Public Space - Entrance

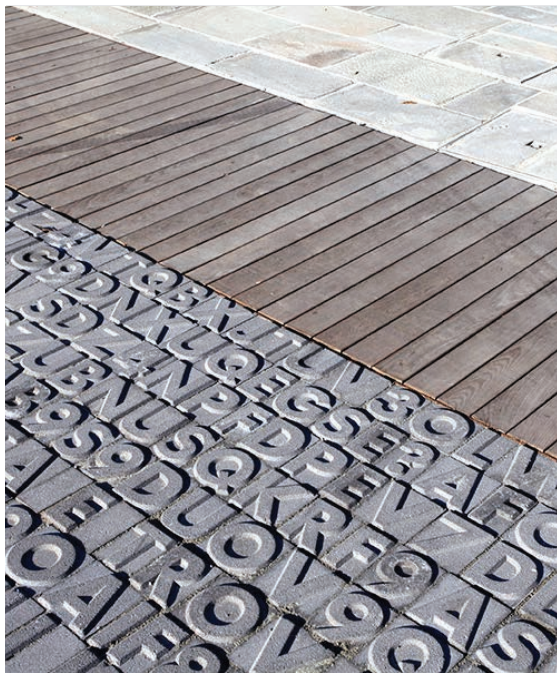
See also note above (2.5.1) regarding the entrance space and its role. Any layout of planting, seating, etc. Within this area needs to be aware and take account of potential security and safety issues in this inner-city location.

Although good surveillance is possible from the reception point / staff office, it would be impossible to effectively intervene swiftly should anti-social behavior occur in the re-entrant space that is outside the building envelope.

Consideration might be given to permeable grills/ security shutters that might allow the partial closure of parts of the space and reduce the extent of the area that is accessible to the public during the overnight period, whilst preserving a good approach to the front entrance?

Planting underneath the entrance would not be recommended as the area is covered and plants might struggle to survive.

Any permeable grills or security shutters that might be incorporated in the building facade could also be complimented by artwork integrated in the paving or around the building entrance.

Homes and Buildings - Courtyard Width

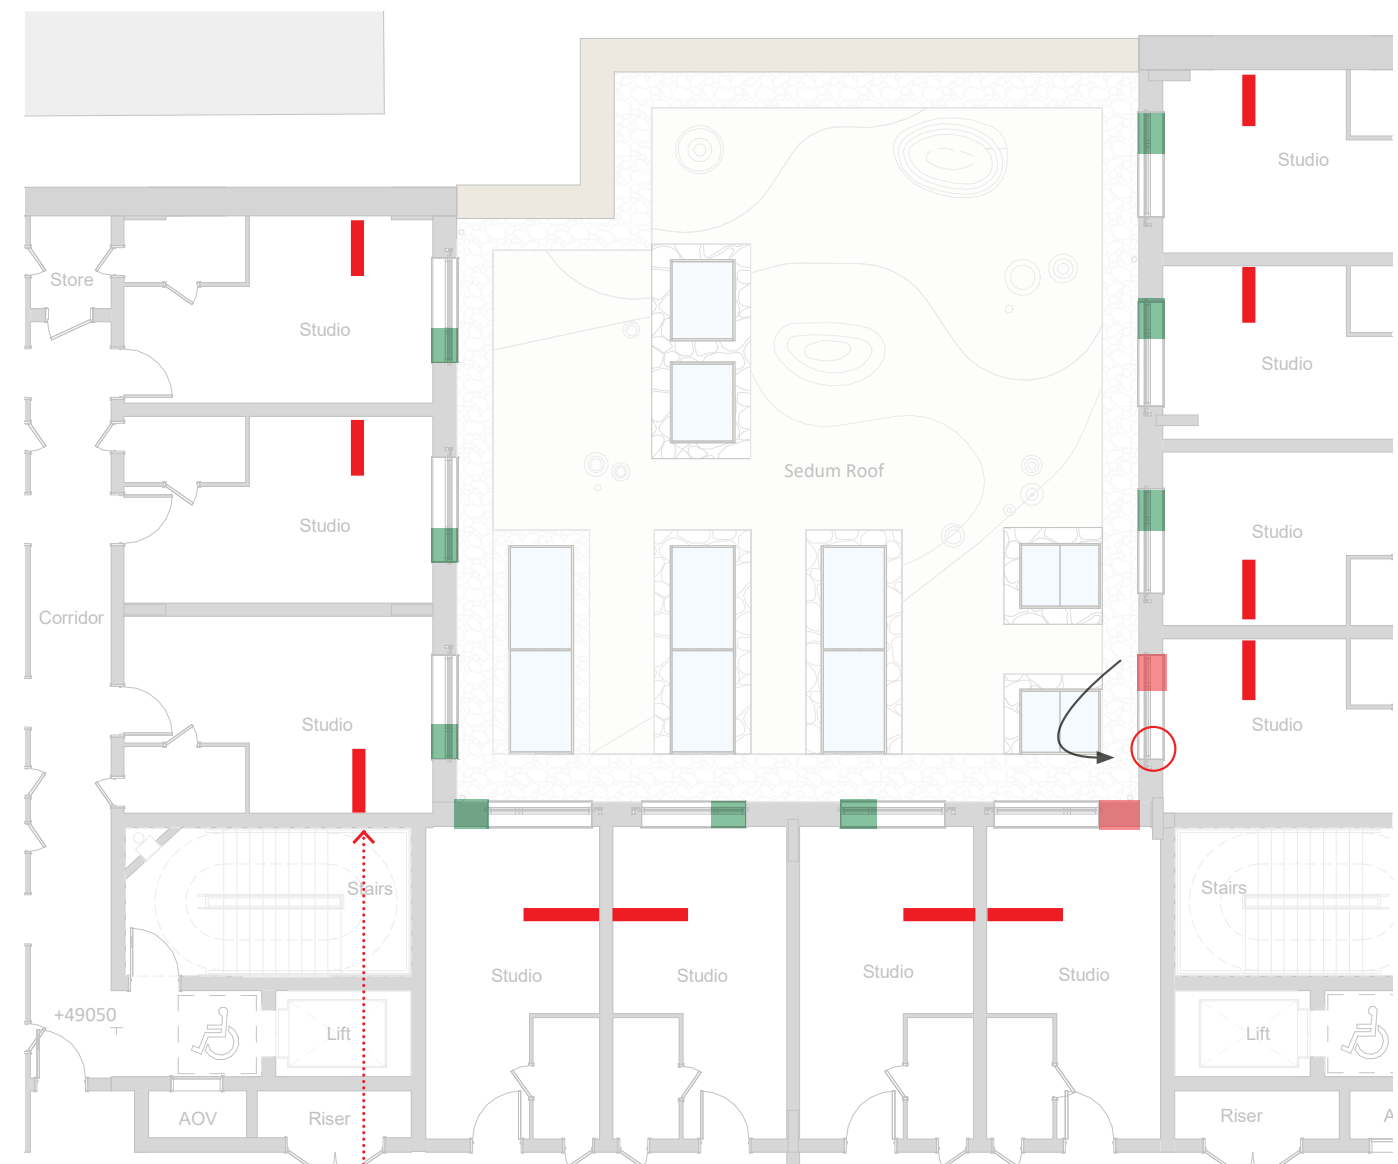
The distance across the internal court is slightly less than 13.5m between opposing windows. The 'bed zones' within each studio commence approximately 2.4m further within, therefore there is approximately 18.3m between opposing sleeping areas.

Although set at 90 degrees to each-other, units forming the internal corners of the court are immediately adjacent which means that centerline to centerline of glazing is only approx. 3 meters apart.

Whilst visual privacy can probably be mitigated with suitable blinds, acoustic conditions could be difficult for residents - especially during summer months when windows are likely to be open.

We have the handing of the windows on these internal corners to put the vent panels together thus increasing the distance between the glass panels.

In addition to this we can explore the use of privacy film that obscures views at an oblique angle.

In terms of acoustic sensitivities the scheme has been assessed under the new Part O requirements and passes which demonstrates that nighttime overheating (which needs to be assessed with closed windows) is not an issue. These units are on the north side of the building therefore wont be prone to the buildup of heat from the sun during the summer months.

Homes and Buildings - Studio Layouts

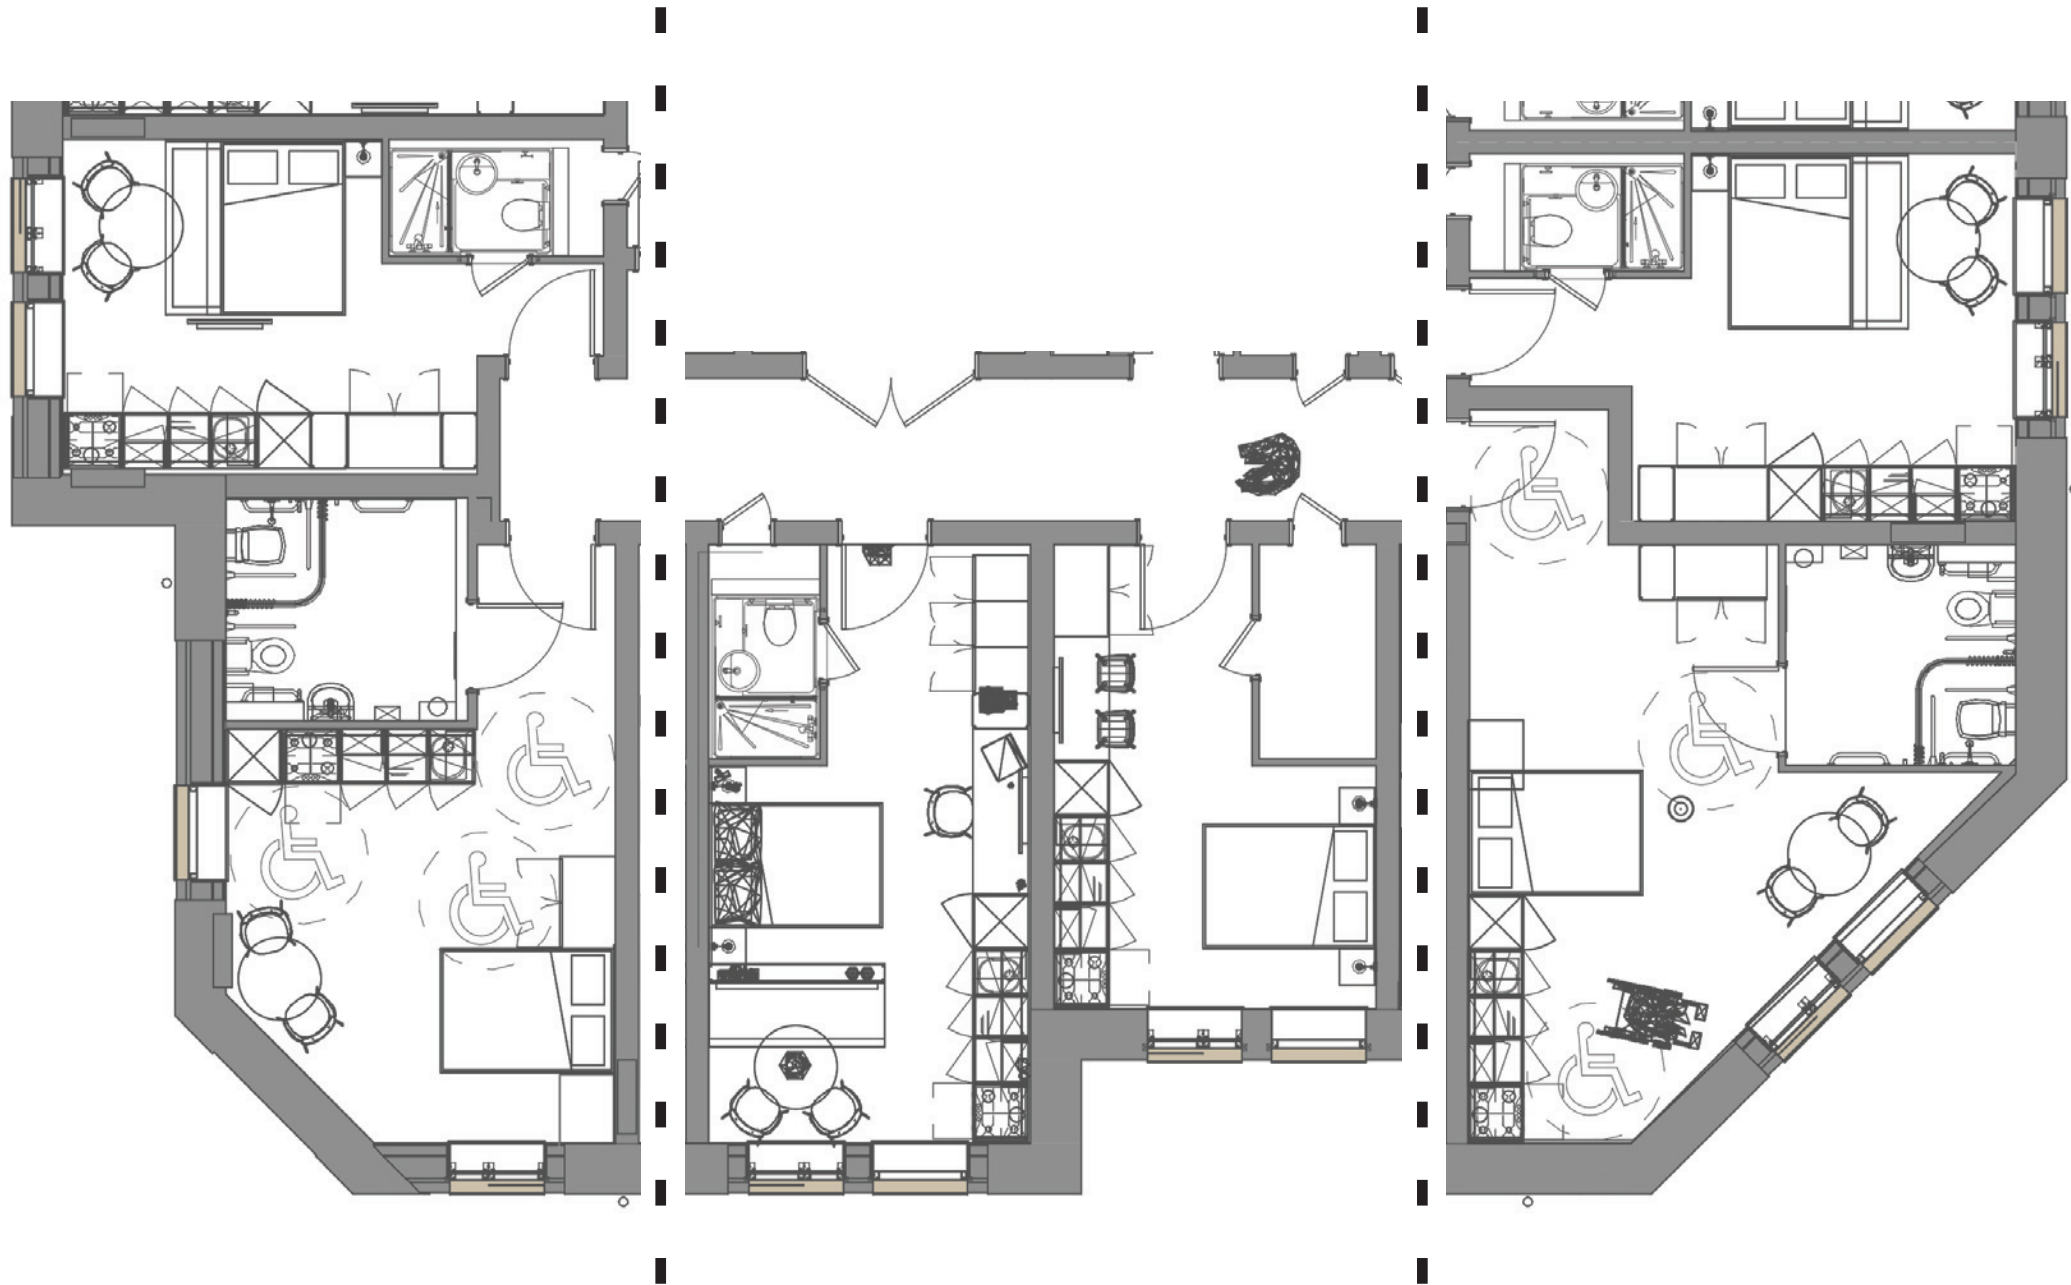
A typical 'studio' is described in detail and provides a good standard of accommodation. However, it is not clear how the considerably smaller units on the front elevation (to either side of the kitchen-dining spaces – [...] could provide a satisfactory layout/sufficient space?

Accessible units occur at the corners and thereby gain some extra space. Their internal layouts have been shown in the DAS – the suitability of these (in detail) will be a matter for building control.

The units adjacent to these on each wing of the development are not able to adopt the standard plan since circulation space to gain access to the corner units reduces the areas available in each (see areas in yellow outline).

The layouts of these units are shown opposite. They offer a different type of accommodation (and price point) giving variety of choice.
